TECHNICAL EVALUATION REPORT

IOWA ELECTRIC AND POWER COMPANY
DUANE ARNOLD ENERGY CENTER

NRC DOCKET NO. 50-331

May 14, 1981

Figure 1. PCIS Control Scheme

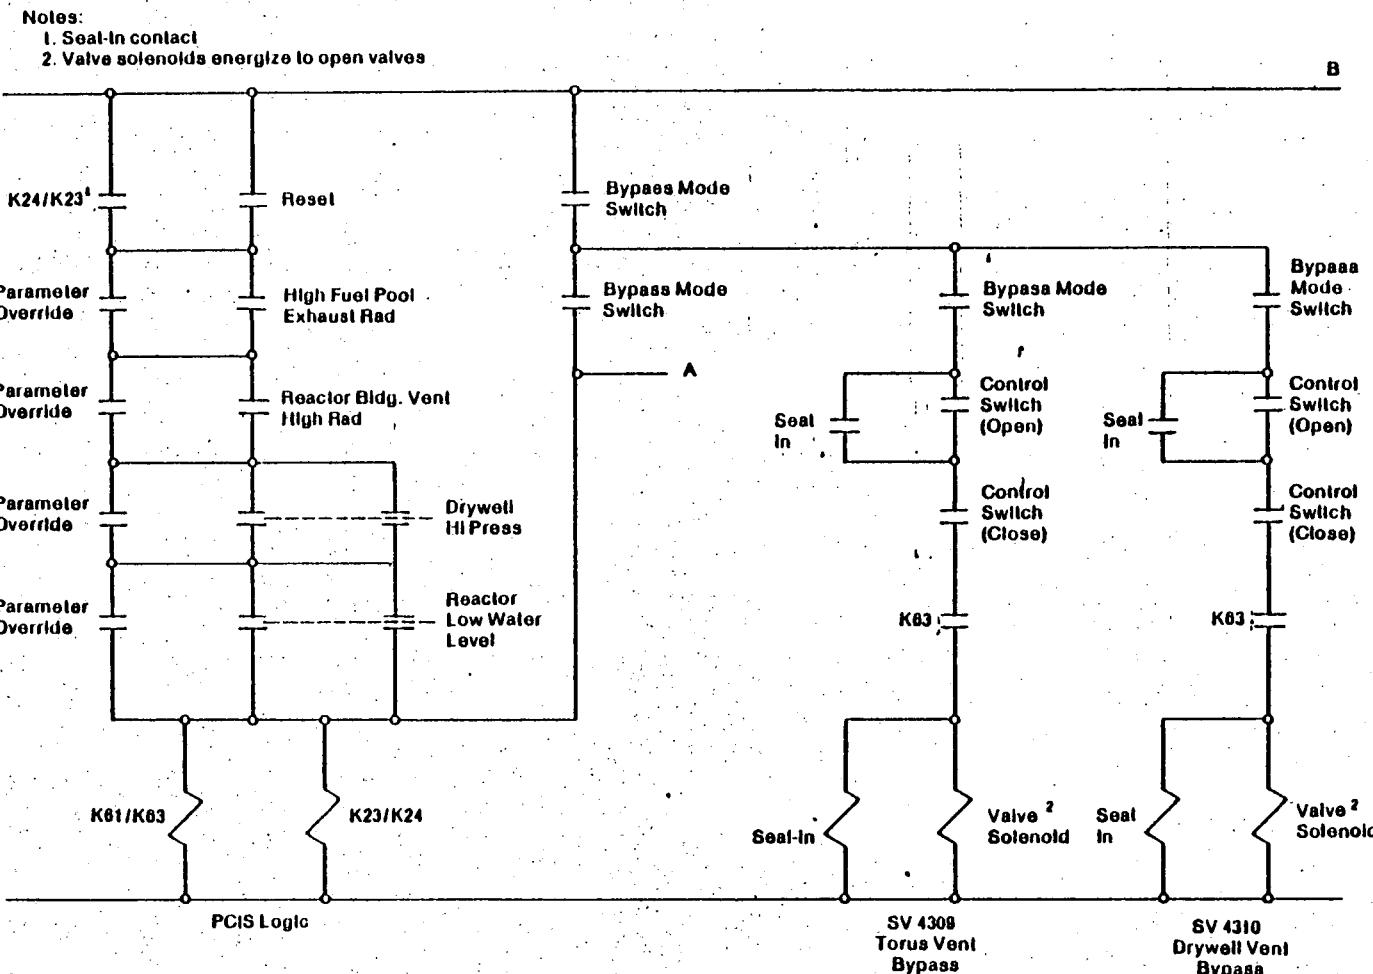
Trip relays associated with each isolation parameter operate contacts, arranged in series-parallel configuration (Figure 1), to provide power to two

slave relays (K23/K24 and K63/K61) in each train via a seal-in relay (K23/K24) contact paralleled by a momentary reset switch contact. The slave relays, when energized, close contacts in the individual valve control circuits in series with the local control switch and solenoid, allowing purge and vent isolation valves to be opened. A contact from one of the slave relays in each train performs the seal-in function. Trip relay contacts are paralleled with parameter override contacts that are operated from a keylock-controlled switch provided for each isolation parameter. Each of these switches also actuates an annunciation circuit to indicate that a specific protection signal has been bypassed.

No instances were found where the overriding of one type of safety actuation signal (e.g., drywell high pressure) causes the blocking of any other type of safety actuation signal (e.g., reactor low level) for those valves that have no function besides containment isolation. Therefore, it was concluded that NRC staff Criterion 1 has been satisfied in the PCIS at DAEC.

Each override switch provides one contact which energizes an amber light in the control room to display the bypass condition to the operator for each individual trip parameter when the switch is placed in the override position. Also, the four override switches in each division of isolation logic are connected to a common annunciator window in the control room, such that any one of the four key switches placed in the override position results in an alarm which requires operator acknowledgment. Therefore, it was concluded that NRC staff Criterion 3 has been satisfied in the PCIS at DAEC.

The four isolation parameters listed in Section 2.2 will automatically initiate containment ventilation isolation. However, there is no radiation detector that monitors the primary containment atmosphere. The two radiation detectors which initiate PCIS monitor the fuel pool area and the reactor building. Therefore, Criterion 4 is not satisfied.

The overriding or resetting of any actuation signal will not cause any valve or damper to change position. This is accomplished by the use of seal-in relays and contacts at the equipment level and also by the provision of reset and override controls at the accident parameter level. Therefore, it was concluded that NRC staff Criterion 6 has been satisfied in the PCIS at DAEC.

It is concluded that the PCIS circuit design at DAEC satisfies the NRC staff criteria for containment ventilation and purging operation with the exception of Criterion 4. Satisfaction of Criterion 4 will require that a radiation detector which monitors containment (i.e., drywell or torus) activity be provided and used to automatically initiate primary containment isolation.

Figure 2. Typical PCIS Valve Control Circuits

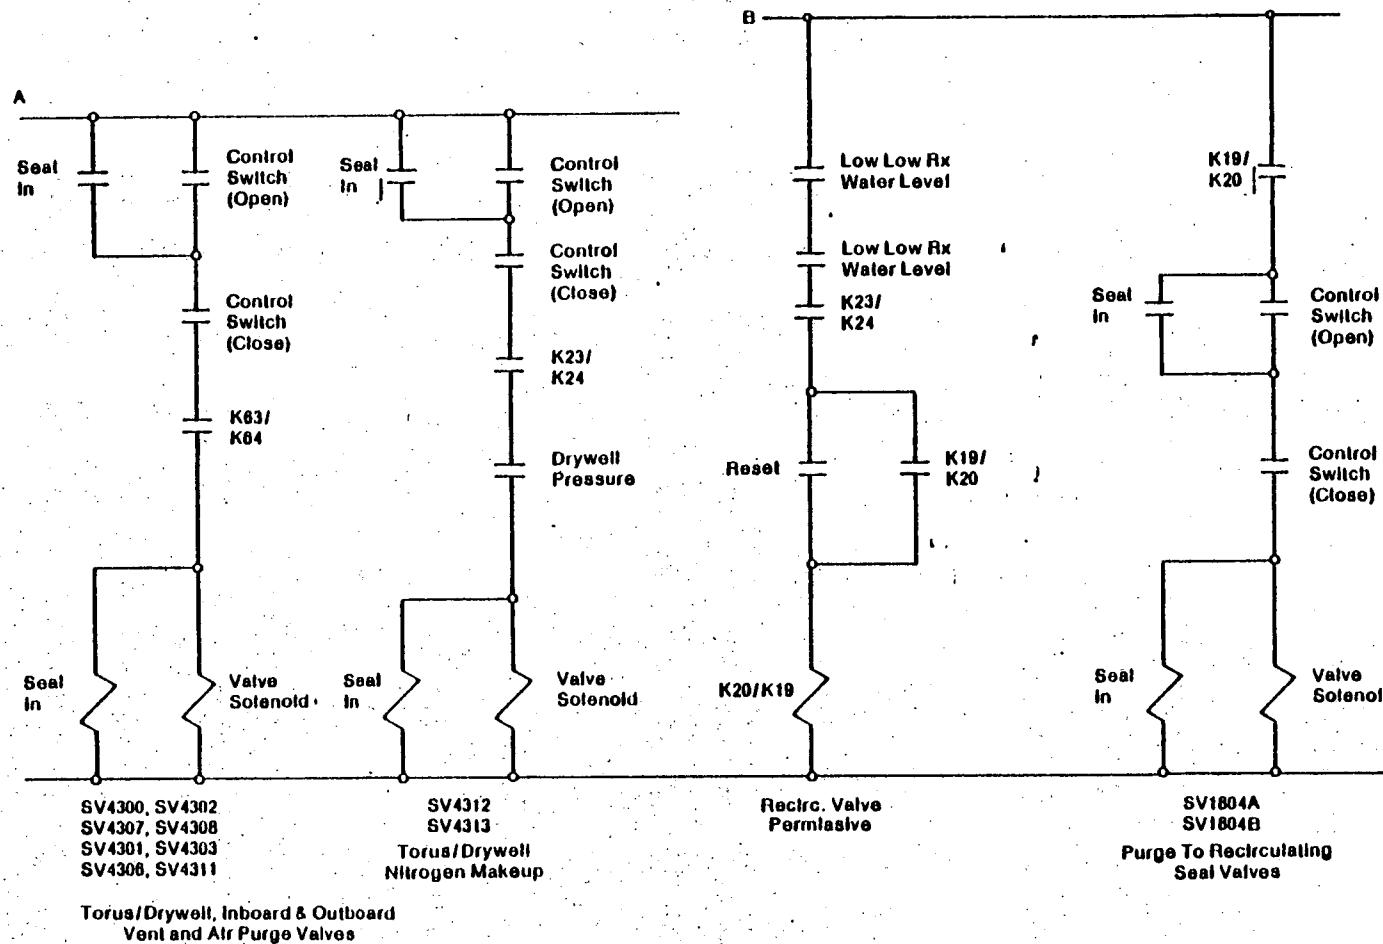
The torus and drywell, inboard and outboard, vent and purge valve control circuits (Figure 2) receive power from the output of the trip logic network (i.e., these control circuits are in parallel with the slave relays). Consequently, the pilot solenoids for these valves may be energized only when all trip signals are cleared or bypassed (the same condition required for slave relay energization). In addition, slave relay contacts are provided in series with each valve operator pilot solenoid.

The valve control circuits for the torus and drywell nitrogen makeup valves (Figure 2) are the same as those for the vent and purge valves with the addition of series contacts which open when the drywell pressure is greater than 1 psig. These contacts provide automatic control of nitrogen inerting the containment.

The valve control circuits for the purge to recirculating seal valves (Figure 2) receive power from upstream of the trip logic network. For these valves, the slave relay contacts operate in a valve permissive circuit in lieu of directly activating contacts in the valve control circuits. The valve permissive relay is in series with two sets of reactor low-low water level

Figure 3. RHR Control Logic

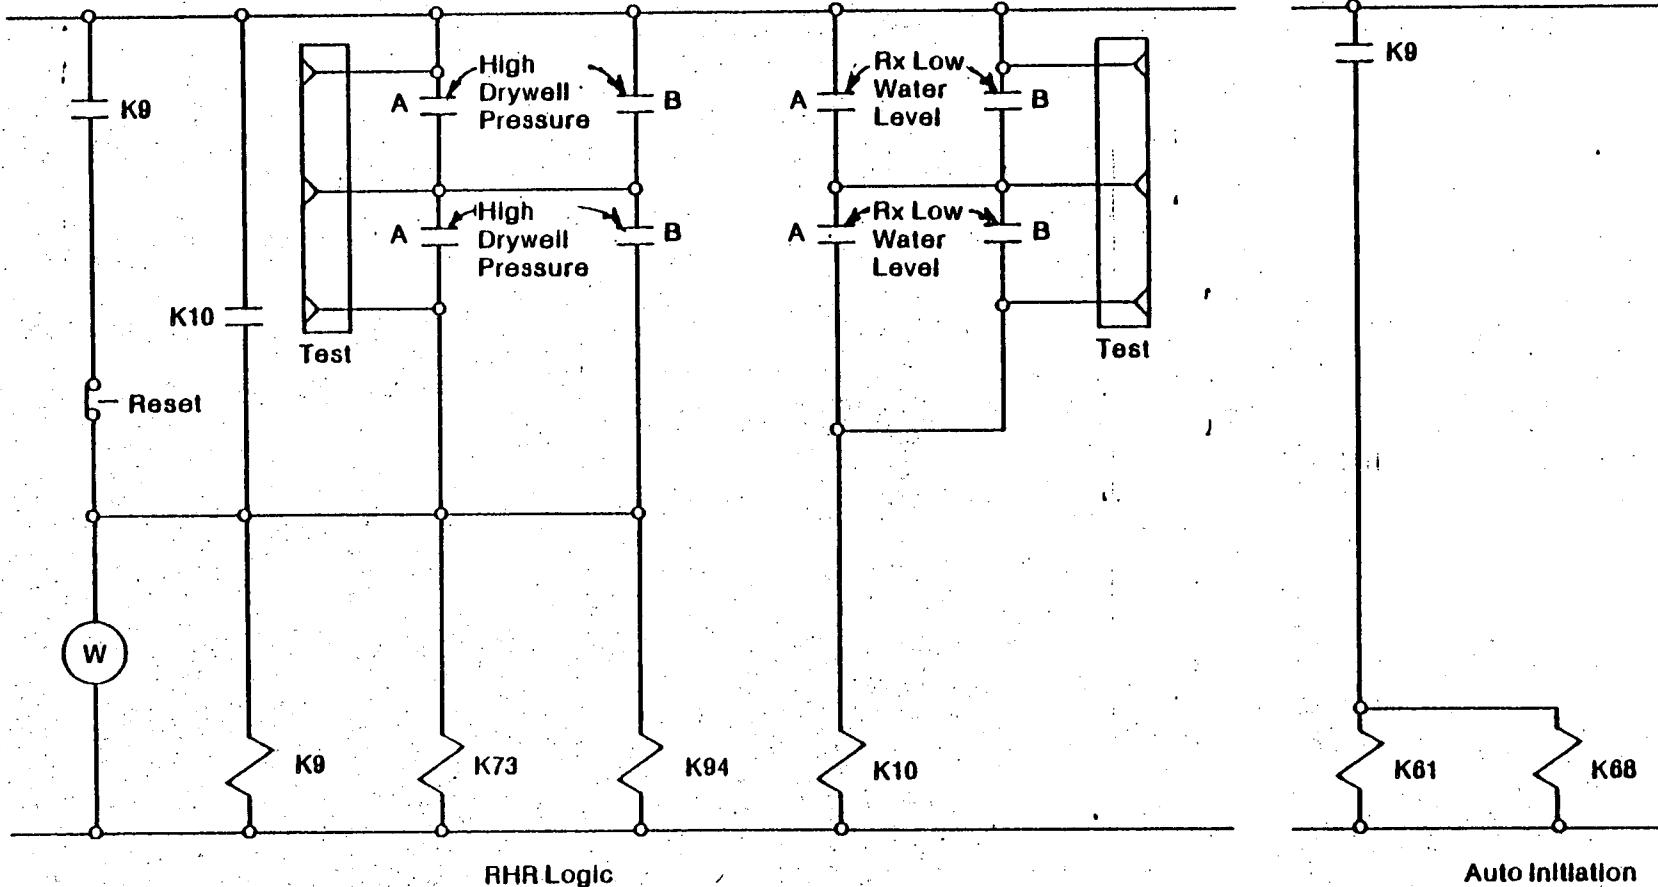
The contacts from the control functions are in an "or gate" configuration and the logic circuit is provided with a seal-in relay (K9) and contact as well as a reset control (Figure 3).

The overriding or resetting of any RHR actuation signal will not cause any valve or damper to change position. Therefore, it was concluded that NRC staff Criterion 6 has been satisfied in the RHR system at DAEC.

Figure 4. Containment Spray Valve Control Circuit

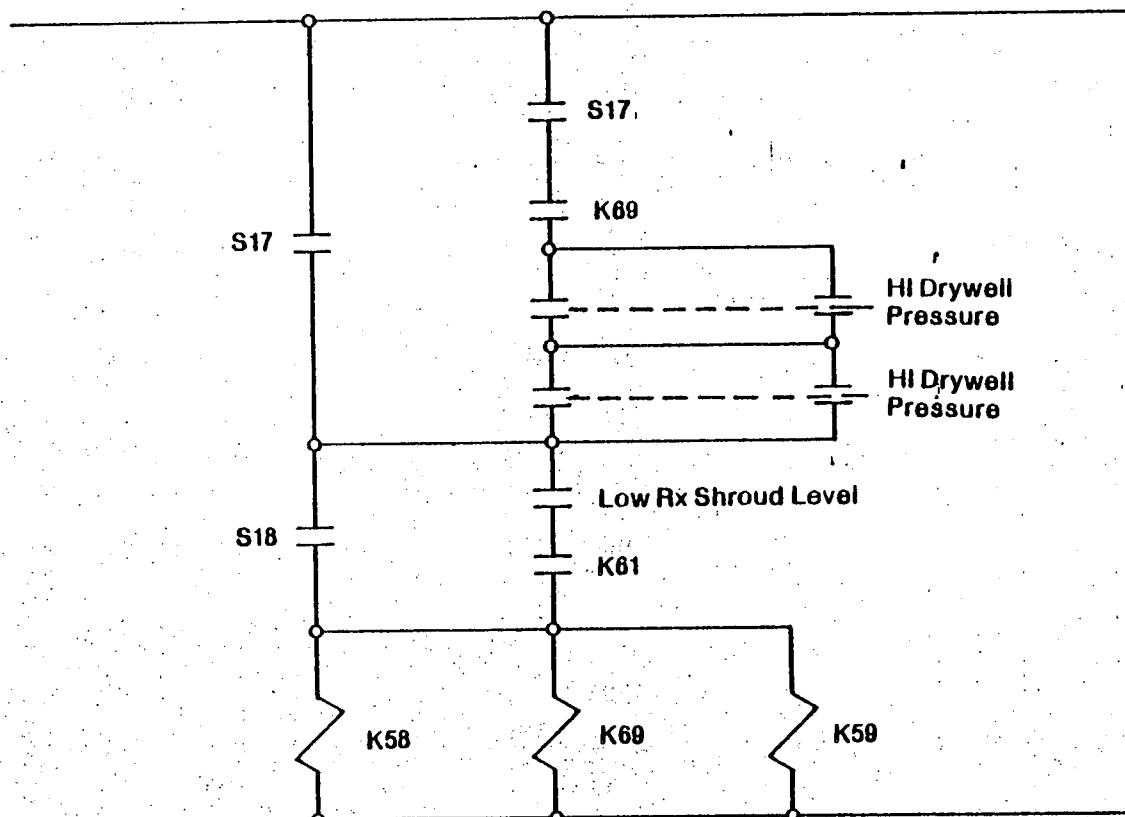
signal for those valves that have no function besides containment isolation. However, ten ESF actuated valves (MO-2000, MO-1902, MO-2005, MO-1932, MO-2007, MO-1934, MO-2006, MO-1933, MO-2001, and MO-1903), which have functions in addition to containment isolation, are provided with control circuitry that allows the bypassing of automatic ESF actuation (see Figures 4 and 5). These valves are normally shut on RHR automatic initiation. They may be opened through the use of two or three manual switches, a local keylocked control switch (42/CS, Figure 5), and either S17 or S17 and S18 (keylocked) depending on the presence of an automatic initiation signal and low reactor vessel shroud level (see Figure 4). Following these manual actions, the automatic initiation of RHR will not cause these valves to close. Although not a literal violation of Criterion 1, this situation has been identified for NRC staff evaluation with respect to acceptability.

Two of the three switches required to bypass the RHR valves identified above (S18 and local control switches) are keylock-type switches and will support adequate administrative controls. In addition, system level annunciation of this condition is provided. Consequently, Criteria 2 and 3 are satisfied for these ten valves. Criteria 2 and 3 do not apply to other RHR valves.

The RHR circuit design at DAEC satisfies the NRC staff criteria with the exception of Criterion 1 for ten valves which have functions in addition to containment isolation. These ten valves (listed in Section 2.4.2.1) may be required to provide containment spray for pressure control of the containment atmosphere in an accident environment. Opening of the valves in question requires multiple switch (keylock-type) operation, and system level annunciation is provided. In view of the possible operational requirements, administrative controls, and annunciation, FRC concludes that no modification to the RHR control circuit design is necessary.
